Product Change Notification - SYST-21LMFR637

ERRATA - PIC32MX1XX/2XX/5XX 64/100-pin Family Silicon Errata and Data Sheet Clarification

PIC32MX1XX/2XX/5XX 64/100-pin Family Silicon Errata and Data Sheet Clarification

17. Module: I/O Port - Initial Pin State

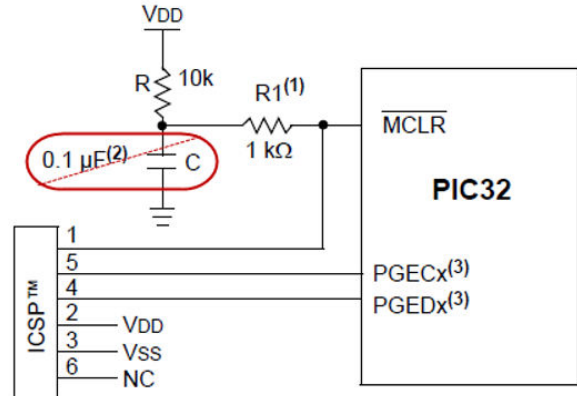
On power-up depending on the VDD ramp rate, the I/O pins can be in an active random output driving state if MCLR is active until a BOR event.

If, not using an external reset supervisor IC or equivalent, remove the MCLR capacitor as shown below, and retain the MCLR Pull-up resistor.

If using an external reset supervisor IC or equivalent, increase the value of the VCAP capacitor to $\geq 47 \mu\text{f}$ ceramic or solid tantalum capacitor with an ESR $\leq 1 \text{ ohm}$.
